**Subject: Beaver Valley Power Station, Unit No. 1
Docket No. 50-334, License No. DPR-66
Response to Steam Generator Request for Additional Information**

ENCLOSURE 1
RESPONSE TO NRC REQUEST FOR ADDITIONAL INFORMATION (RAI) CONCERNING
THE BEAVER VALLEY POWER STATION UNIT 1 "CYCLE 16 VOLTAGE BASED
REPAIR CRITERIA - 90 DAY REPORT"

ENCLOSURE 2
RESPONSE TO NRC REQUEST FOR ADDITIONAL INFORMATION (RAI) CONCERNING
THE BEAVER VALLEY POWER STATION UNIT 1 "CYCLE 16 VOLTAGE BASED
REPAIR CRITERIA - 90 DAY REPORT APPENDIX A - RAI RESPONSE"

Figure 1

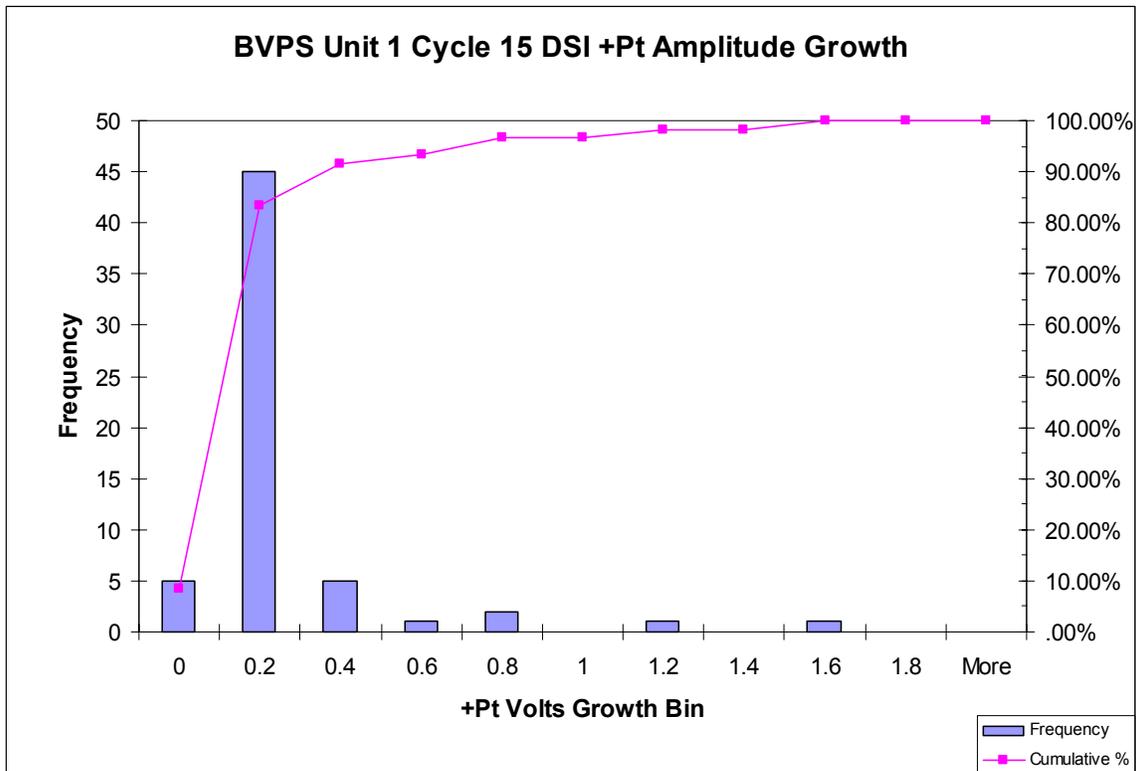
Given the findings at Diablo Canyon Unit 2, discuss the +Point results, if any, for the larger voltage indications left in service during the 2003 refueling outage (1R15). Also discuss whether the indications with the largest growth rates in Cycle 15 were inspected with a rotating probe during the current (2003) and/or the previous (2001) outage. Discuss any observations from the rotating probe profiling of these indications, the bobbin and rotating probe voltages of these indications, etc. For example did the indications with the largest bobbin voltage growth rates have large rotating probe amplitudes (when compared to the bobbin amplitude) at the beginning of the cycle (i.e., during the 2001 outage (1R14))? Did the rotating probe data acquired at the beginning of the cycle (i.e., during the 2001 outage) indicate the flaw was nearly through-wall and the subsequent rotating probe data at the end of the cycle (in 2003) indicate the flaw had penetrated through-wall?

Bobbin growth data for all S/Gs were reviewed. Growth distributions for Cycle 15 are slightly reduced compared to Cycle 14, and likely due to the removal of deposits from crevice regions due to chemical cleaning at 1R14. All 1R15 DSI's with ≥ 1.00 volt growth were reviewed to determine if a Plus Point test was performed in 2003 (1R15) and 2001 (1R14). A total of 5 DSI's were found in this population. Two were not tested at 1R15, one had a 1R15 Plus Point amplitude of 0.77 volts but was not tested at 1R14, and the other two had Plus Point amplitude growths of 1.75 and 1.01 volts. For S/G "A", data

for all DSI's >1.5 volts was reviewed. The average DSI growth for these (94) indications is 0.25 volts. The average Plus Point voltage growth (27 indications) is 0.25 volts.

S/G "A" contains the largest number of DSI's, and contained the largest singular DSI amplitude for 1R15. The average voltage growth was 0.25 volts for 1R15 DSI indications with ≥ 1.5 DSI volts. This includes one indication with bobbin voltage growth of 3.25 volts, and 2 indications with bobbin voltage growth of 1.01 volts. At 1R15, S/G "A" contained 94 indications with ≥ 1.5 DSI bobbin volts. Of these 94, the 1R15 and 1R14 data was reviewed to determine if a Plus Point examination occurred in each outage. For those indications with Plus Point exam in both outages, the average Plus Point amplitude growth was 0.25 volts. It should be noted that the 1R15 Plus Point reporting channel was 200 kHz due to a change in the EPRI Examination Technique Specification Sheets (ETSS) whereas the 1R14 Plus Point reporting channel was 300 kHz. The 1R15 200 kHz Plus Point amplitudes were reduced by 10% to account for the difference in amplitude responses between the two frequencies. The largest 1R15 DSI was reported at 4.57 volts, with a Plus Point amplitude of 2.12 volts. The bobbin growth for this indication was 3.25 volts, and the Plus Point growth was 1.51 volts. The largest Plus Point amplitude for a DSI was also reported in S/G "A", at 2.47 volts. The Plus Point growth for this indication was 0.76 volts while the bobbin growth was 1.01 volts. Based on the Plus Point amplitude to maximum depth correlation, this indication was approximately 95% through-wall (TW) at 1R14. For the most part, the 1R15 indications with > 1.5 DSI volts did not have Plus Point amplitudes that suggested 100% or near 100% TW degradation. Of the 1R15 DSI's Plus Point inspected, the only intersections with potentially 100% TW degradation are the two discussed above, and one other indication in S/G "A". The bobbin coil DSI amplitude for this indication is 1.93 volts with a 200 kHz Plus Point amplitude of 1.99 volts (1.79 volts measured in 300 kHz). The maximum depth from 300

kHz phase analysis was 94% TW, while the maximum depth from correlation of Plus Point volts was 89% TW. This tube (S/G "A" R22 C36) remains in service.

Figure 2

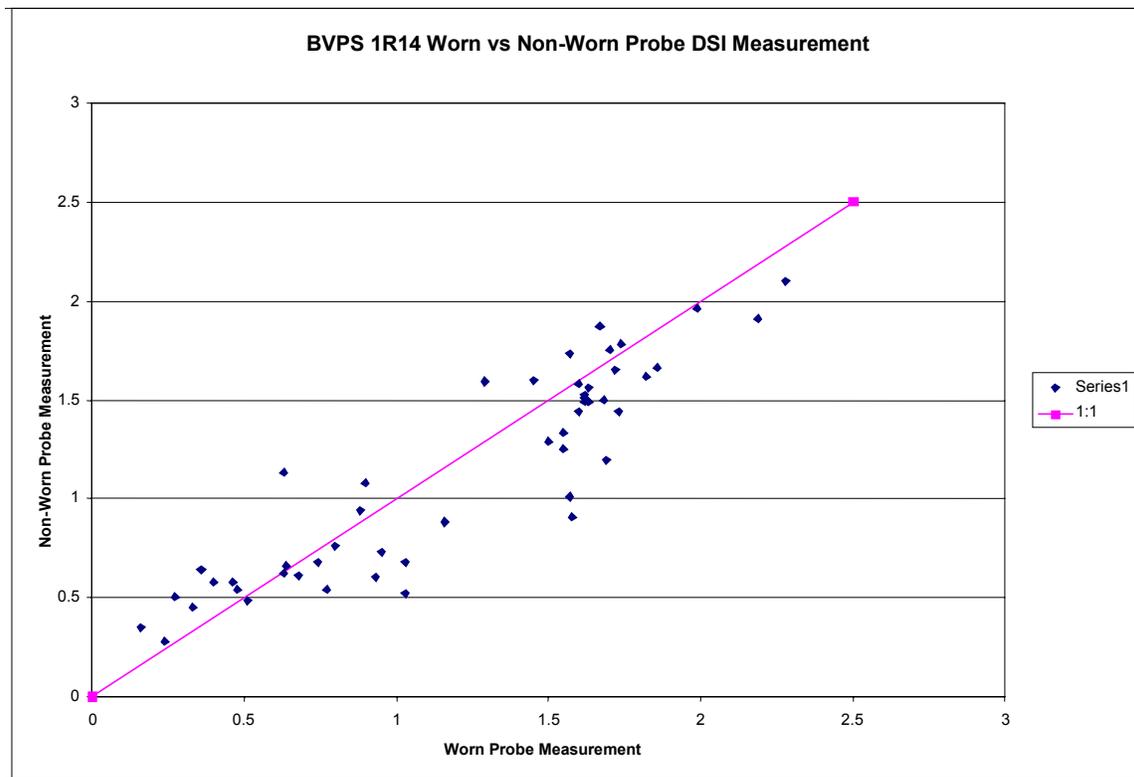
Section 3.3 of the 90 Day Report, "Probe Wear Criteria," states that only 6 of the 628 new indications found in the EOC 15 inspection were in tubes inspected with a worn probe during the EOC 14. While this is a low absolute number of new indications in tubes previously inspected with a worn probe, compare the percentage of tubes that failed the probe wear check (in 1R14) and had new indications detected in the 1R15 inspection to the percentage of tubes that passed the probe wear check (1R14) and subsequently had new indications detected in the 1R15 inspection. The Nuclear Regulatory Commission (NRC) staff's concern is illustrated in the following hypothetical example. Suppose 20 new indications were detected during an outage. Further, suppose 10 of these new indications were associated with a probe that failed the probe wear check in the previous outage and 10 were associated with a probe that passed the probe wear check during the previous inspection. If 100 tubes were inspected with a worn probe and 10,000 tubes were inspected with a probe that passed the probe wear check, 10% of the intersections inspected with the worn probe contained indications at the next outage while only 0.1% of those inspected with a "non-worn probe" had new indications. This may indicate the alternate probe wear criteria is causing degradation to be missed. Were any new indications detected with new probes that were not detected with worn probes?

to the detection of insignificant indications. Any effect upon detection would be found in indications well less than 1.00 volt. The current 0.6 POD more than accounts for any influence of worn probes on detection of < 1.00 volt DSI's. For the 1R14 inspection, a comparison of amplitude responses for intersections affected by a worn probe was performed for the non-worn probe data. The average amplitude difference (non-worn minus worn) was found to be negative 0.08 volts, suggesting that the worn probe amplitude is generally larger than the non-worn probe amplitude.

Figure 2 presents this plot. For the 1R14 inspection, only one new DSI was reported as a result of testing with a non-worn probe. The DSI amplitude was 0.32 volts. For the 1R15 inspection, the amplitude of the largest DSI (of six) not reported from the worn probe test was 0.74 volts. The average difference (non-worn minus worn) was found to be negative 0.06 volts, indicating that the worn probe amplitude is generally larger than the non-worn probe amplitude.

Figure 3

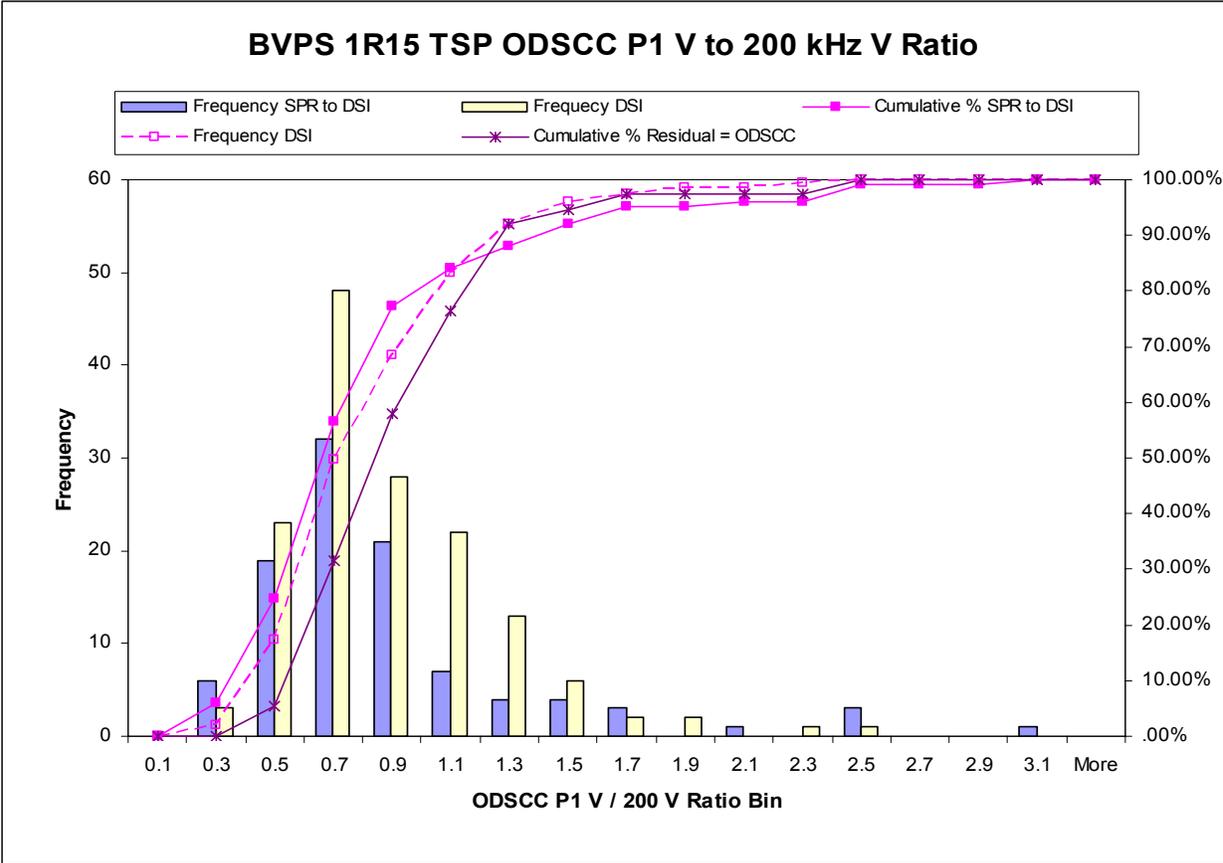
The intent of question 4 was to ascertain whether there is a difference between the 200 kHz to 400/100 kHz "relationship" for indications with SPR's to those without SPR's. If there was no difference one could argue that the SPR had no effect on the mix voltage. If there was a difference between the relationship (if any), one could argue that the SPR was affecting the 400/100 mix voltage readings. It is not clear from the response why this is an "indirect" comparison. In addition, it is not clear what the intent of evaluating the ratio of the residual voltage to the ODSCC voltage for the two populations indicates with respect to whether 1 volt indications are being missed or misread. Please provide the originally requested plot.

Unless a DSI report is large (> 3.00 to 4.00 volts) such that it overwhelms the inherent residual, nearly all intersections called DSI contain a mix residual with an amplitude that exceeds the amplitude of the DSI. With the exception of large voltage DSI's, all indications within the existing ARC ODSCC database contain residual components and the effects of these components are present in the current methodology. Examining only those DSI's with no or negligible residual response is not representative of the entire ODSCC database, or the distribution of residual and ODSCC for either the DSI or SPR population at BVPS Unit 1.

Figure A-5 (of the 90 Day Report) shows that the ratio between 200 kHz and 400/100 mix channel amplitudes is consistent for indications initially called DSI and indications initially called SPR and subsequently changed to DSI based on Plus Point confirmation. Figure A-5 answers the question concerning SPR affect on measurement of the DSI amplitude. The SPR is not affecting the DSI amplitude measurement. If the residual were affecting the measurement of the ODSCC amplitude, the

two data sets would be significantly different. The existing database contains any effect of mix residual upon voltage measurement. In lieu of reevaluation of all of the 1R15 bobbin data, which would incur significance expense without providing any additional pertinent information, the 166 intersection sample used to develop Figure A-5 was reviewed and those intersections where the mix residual to ODSCC measurement ratio was < 1.1 were considered. Note that the maximum ratio for the entire 166 intersection sample is 5.125 (0.82 volt residual with a 0.16 volt ODSCC measurement). Figure 3 provided herein is Figure A-5 of the 90 Day Report, with those intersections with a residual to ODSCC ratio of < 1.1 plotted separately. For the entire 166 intersection sample, the average P1 to 200 kHz voltage ratio is 0.803, whereas for the subset of intersections with residual to ODSCC ratio < 1.1 is 0.908. A total of 38 intersections are found in this subset. For those intersections initially called SPR, the P1 to 200 kHz average ratio is 0.788. Figure 3 shows that the distribution of P1 to 200 kHz voltage ratios is essentially equal to the same ratios for the 166 DSI sample and SPR confirmed to contain ODSCC based on +Pt examination.

For intersections called DSI, there is a wide spread between the residual (which is not reported as part of the normal field analysis) and the ODSCC amplitude. This spread is similarly wide for those intersections called SPR and subsequently determined to contain ODSCC from Plus Point testing. To compare the SPR data with only those DSI intersections with residual signals of nearly equal amplitude to the ODSCC is not a comparison of the entire data sets, but a comparison of a small portion of one dataset to a second entire dataset. Thus, the comparison is indirect.
